Application No.: 09/892,662
Amdt. dated February 22, 2005
Reply to Office Action dated August 19, 2004

AMENDMENTS TO THE DRAWINGS

Title: LIQUID CRYSTAL DISPLAY DEVICE AND DRIVING METHOD
THEREOF

FIG. 1
CONVENTIONAL ART

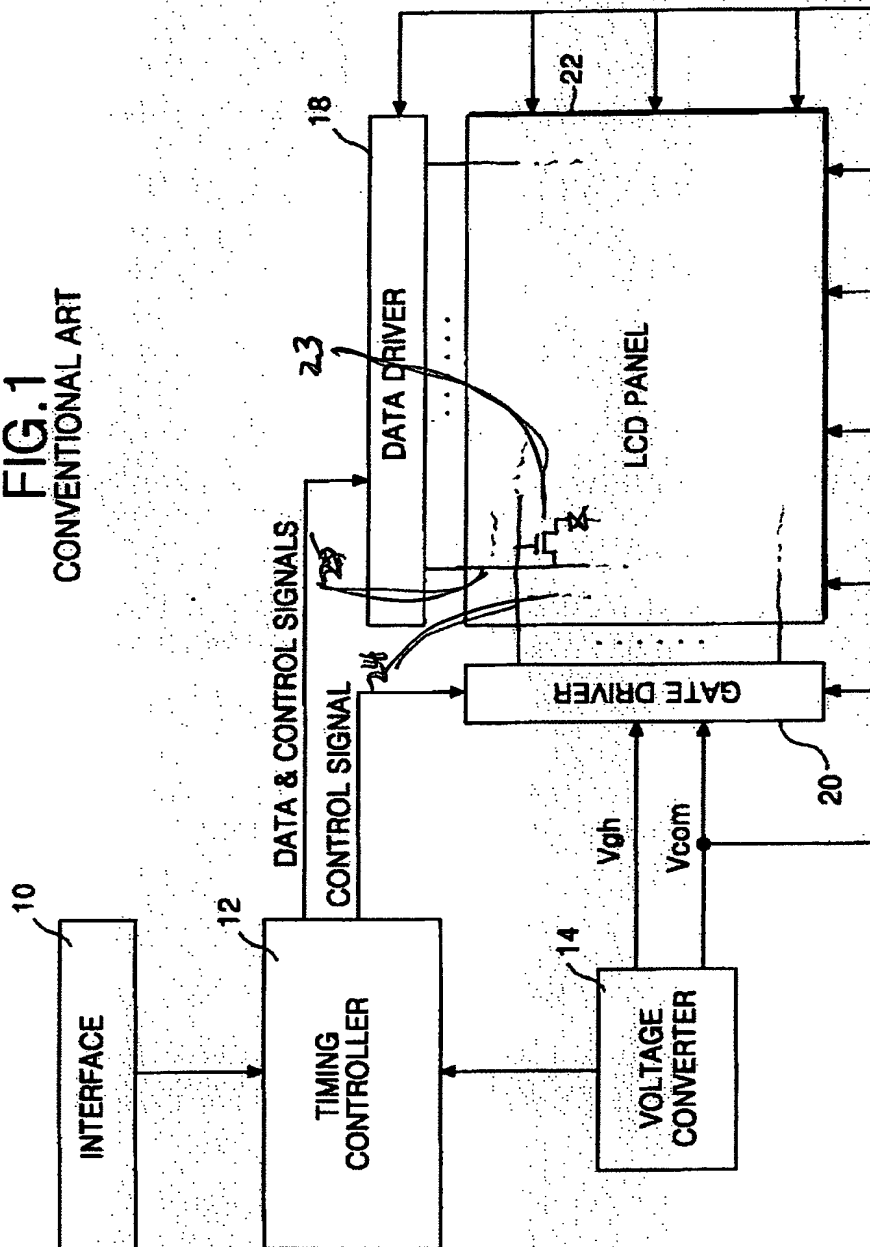
The drawings have been amended as follows. Previously omitted thin film transistor 23, scan line 24, and data line 25 are now shown in Figures 1, 3, 4, 6, 7, 9, and 10.

The attached sheets of drawings include changes to Figures 1, 3, 4, 6, 7, 9, and 10. These sheets, which include Figures 1, 3, and 4-10, replace the original sheets including Figures 1, 3, and 4-10. The following changes have been made to Figures 1, 3, 4, 6, 7, 9, and 10: previously omitted thin film transistor 23, scan line 24, and data line 25 are now shown in Figures 1, 3, 4, 6, 7, 9, and 10. It is respectfully submitted that no new matter has been entered.
